Re: Initial Submission Review: High Point - Catawba and 63rd Parking Lot Site Plan – Site Plan and Replat
Application Number: DA-2233-09
Case Numbers: 2025-6013-00; 2025-3016-00

Initial Submission Review

Re: High Point-Catawba and 63rd Parking Lot, Case # DA-2233-09

Subject: 1882170 – High Point Catawba and 63rd Parking Lot Site Plan & Replat

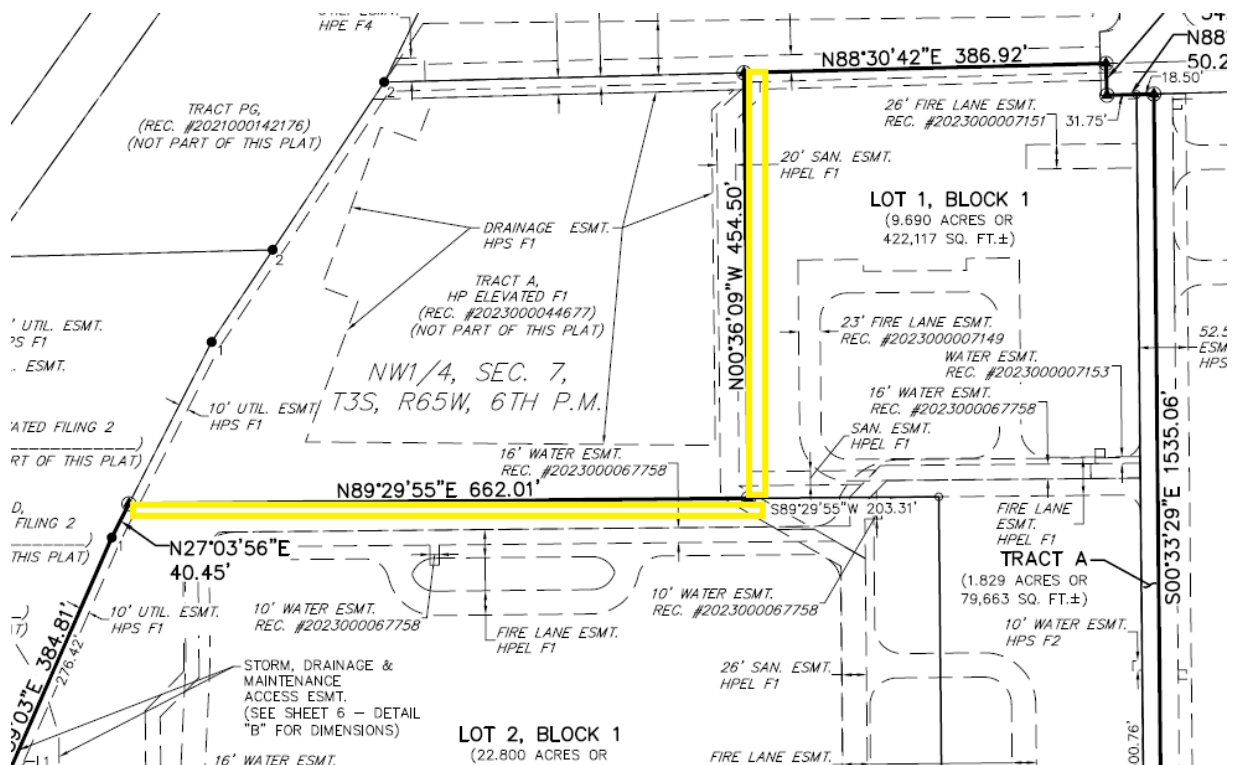
Public Service Company of Colorado's (PSCo) Right of Way & Permits Referral Desk has reviewed the replat and site plan for **High Point-Catawba and 63rd Parking Lot** and requests 10-foot-wide utility easements dedicated on the plat in the areas indicated in yellow below:
